This Response to Office Action is being submitted in response to the Office action mailed on November 7, 2003 in Serial No. 10/044,774.

**SUCTION NOZZLE CONFIGURATION
RELATED APPLICATIONS**

Application No. 10/044,774
Amendment Dated Feb. 17, 2004
Reply to Office Action of
November 7, 2003
ANNOTATED SHEET
SHOWING CHANGES

FIG-1

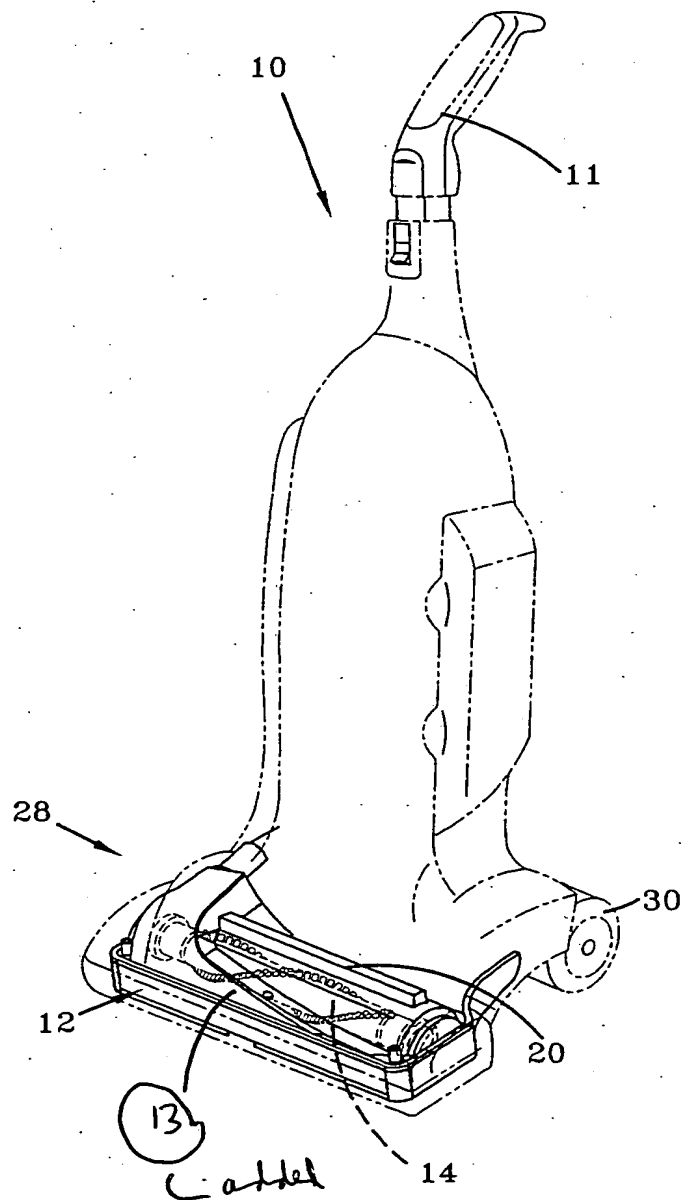
The Examiner objected to the drawings as failing to comply with 37 C.F.R. 1.84(p)(5) because they do not include the following reference sign(s) mentioned in the description: 13(not is figure 1, as disclosed, page 3, line 16) and 320 (page 9, line 2). Corrected drawings have been submitted where reference sign 13 has been added to figure 1 and 320 has been added to figure 8. Additionally, applicant has amended the specification to refer to channel "20" as channel "520" and has amended figure 10 accordingly.

FIG-2

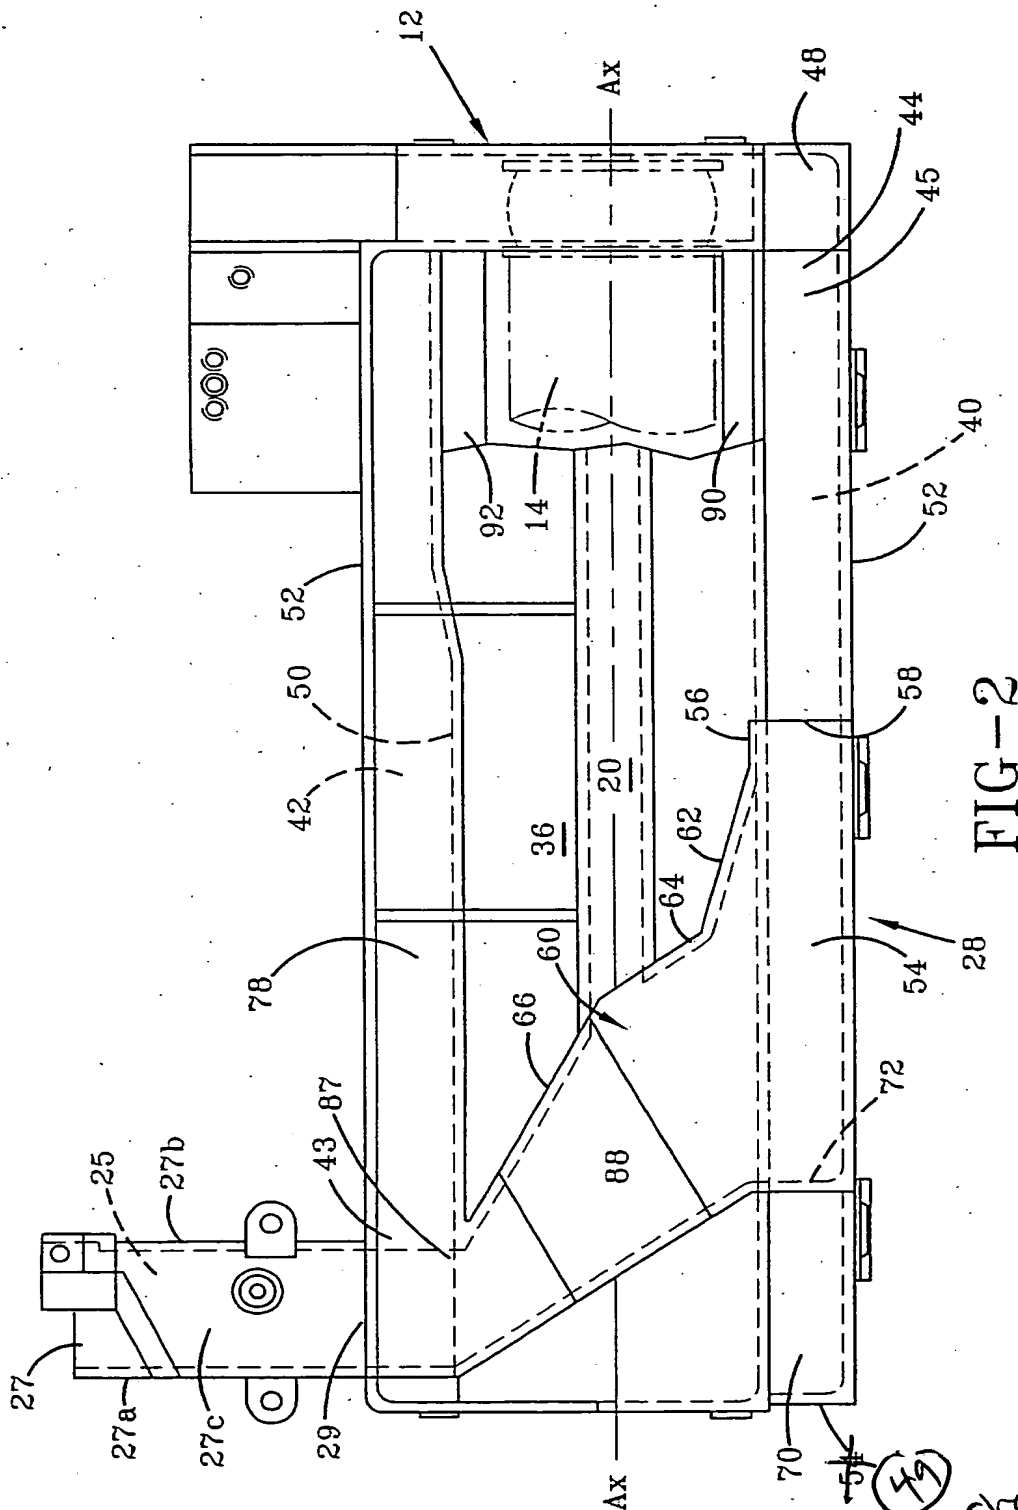
The Examiner objected to the drawings as failing to comply with 37 C.F.R. 1.84(p)(4) because a) reference character "27" has been used to designate both side discharge duct (page 4, line 4), rear discharge duct (page 4, line 14) and suction connection (page 7, line 21) and b) reference character "54" has been used to designate both transition section (page 5, line 19) and opposite end (page 6, line 10). The specification has been amended on page 4, line 14 so that reference character "27" is referred to correctly as "rearwardly extending side discharge duct" as it is referred to on page 4, line 4. Reference character "54" has been changed in figure 2 to "49" to correctly reflect the opposite end referred to on page 6, line 10.

Changed to
 "49"

FIG-9

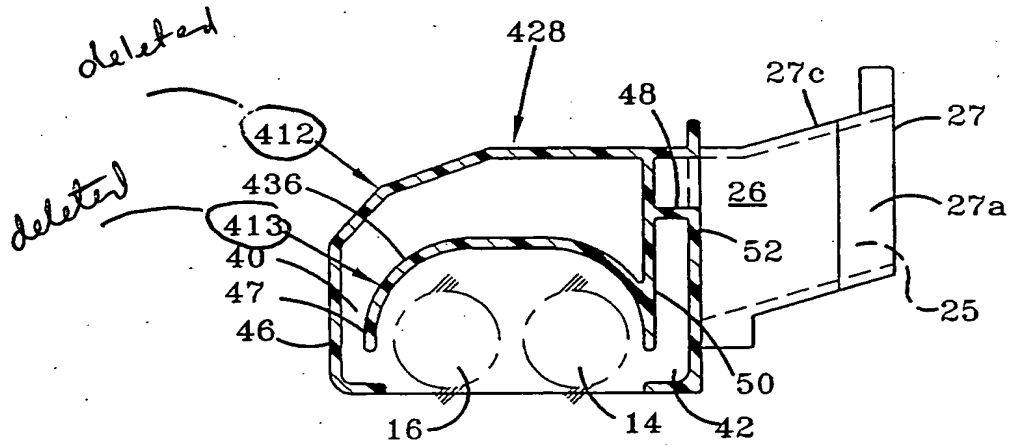
The Examiner objected to the drawings as failing to comply with 37 C.F.R. 1.84(p)(5) because they include the following reference sign(s) not mentioned in the description: 412, 413 (figure 9) and 512,513 (figure 10). Corrected drawings are submitted where the reference sign(s) 412, 413 (figure 9) and 512, 513 (figure 10) have been eliminated. The reference signs were eliminated as not being necessary to describe the invention.
